PLANNING BOARD AGENDA

MAY 13, 2024
REGULAR MEETING

**Re: Completeness/Technical Review
Duda Variance Application
1805-1805 ½ Parkway
Block 17, Lot 3
H2M Project No. LKCP 2402**

FOUNDATION PLAN
 FIRST FLOOR PLAN
 SECOND FLOOR PLAN

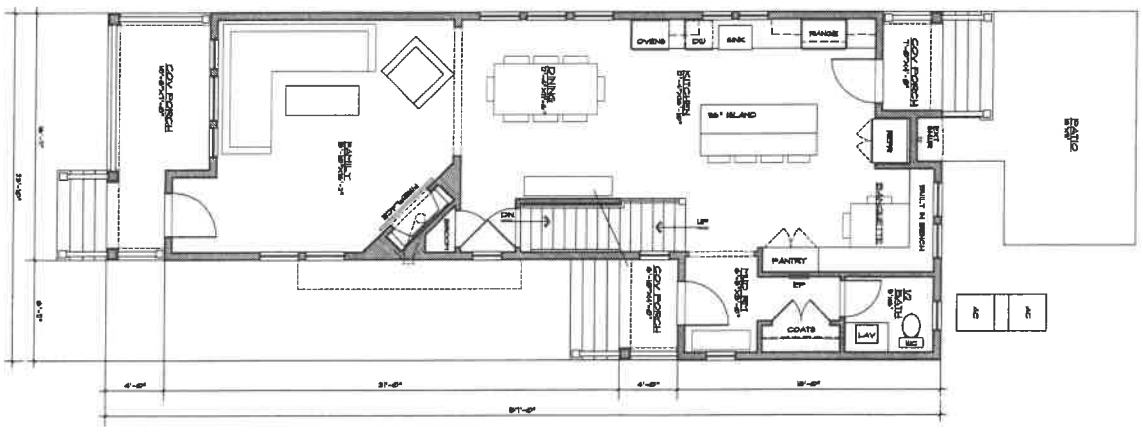
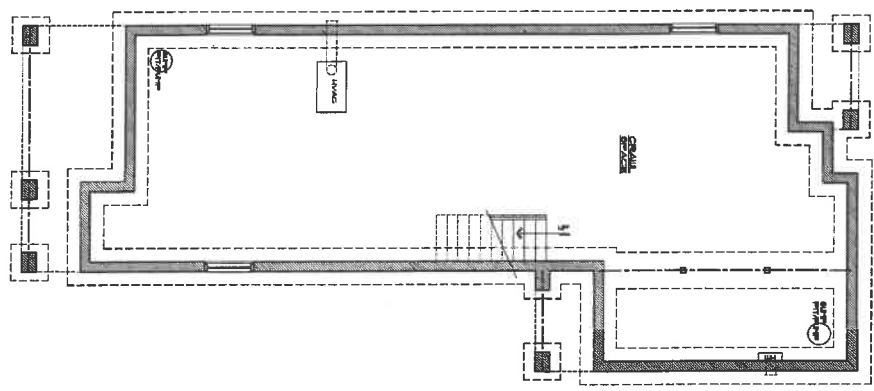
6. The architectural plans depict a side wall vent for the proposed fireplace that appears to discharge beneath the proposed cantilevered second floor. This is more a code issue than zoning; however, the Board should confirm with the Applicant's architect that such a condition is permissible by the prevailing building code.

PROPOSED PLOT PLAN SCALE IN FEET (1"=10')

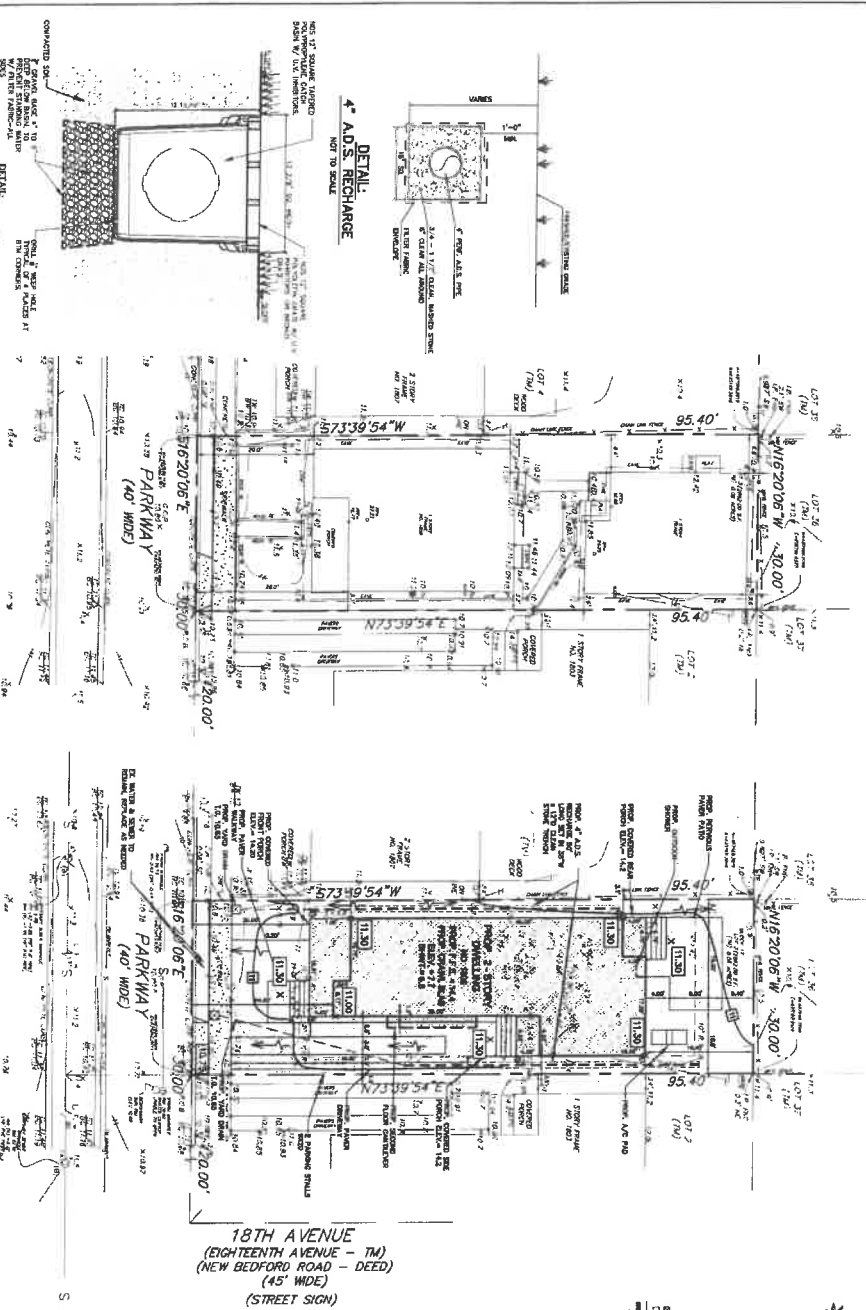
1. Code Section 17-9.1(d) sets forth the Requirements within the R-40 Zone. A review of the plans in conjunction with this section identified the following non-conformities:
 - Lot Area – 4,000 square feet required, 2,862 square feet existing;
 - Lot Frontage – 40 feet required, 30 feet existing;
